Access Compliance Report

Public Rights-of-Way

(Curb Ramps)

Intersection ID: 28611	Main Street: FALCONCREST_DR	Cross Street: KESTRAL_RIDGE_DR	Location:	N
ADA ID: EC2E1D14E4A4	Ramp Type: PerpDiag	Initial Pass/Fail: Pass	Overall Compliance: No	Severity Score: 2.5
Codes/Mitigation Info/Possible Solution		Field Measurements/Component Compliance

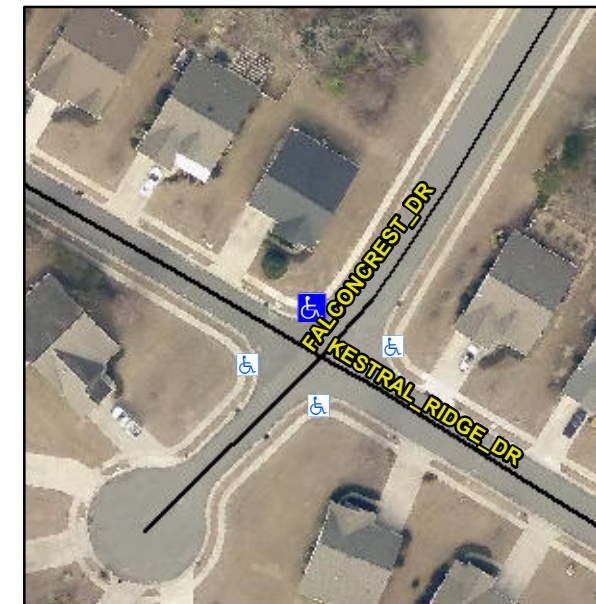
Remove & Replace Curb Ramp With Two New Directional Ramps or Equivalent.

Not Found, R304.2.2-Perp, R304.3.2-Para, R305.1.4, R305.2
